Title: Improved PHR coding of the MR-O-QPSK PHY

Re: Task Group 15.4g LB51 comment resolution

Abstract: Comment resolutions related to PHR coding of the MR-O-QPSK PHY

Recommendation A: SpreadingMode distinguished by SFD

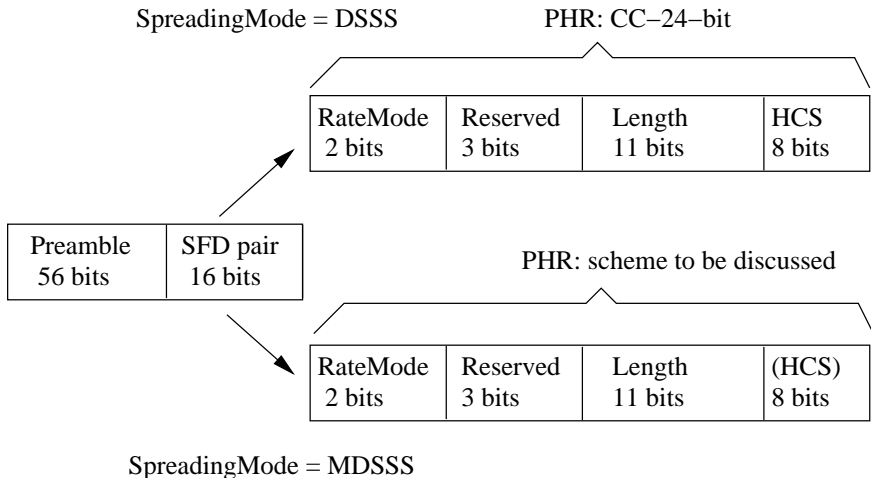
- ▶ CC-24-bit (terminated convolutional coding)
 - ▶ proven approach (similar to IEEE 802.11a/g, TG4g OFDM PHY)
 - ▶ 3 octets (24 info bits), while hiding 6 bit termination from the PPDU view
 - ▶ termination supports fast traceback
 - ▶ hardware for PSDU FEC can be reused
- ▶ CRC-8 based HCS
 - ▶ sufficiently robust
 - ▶ can be nicely integrated into CC-24-bit
- ▶ extend SFD to 16 bit: reduce preamble by one octet in order to sustain overall SHR length
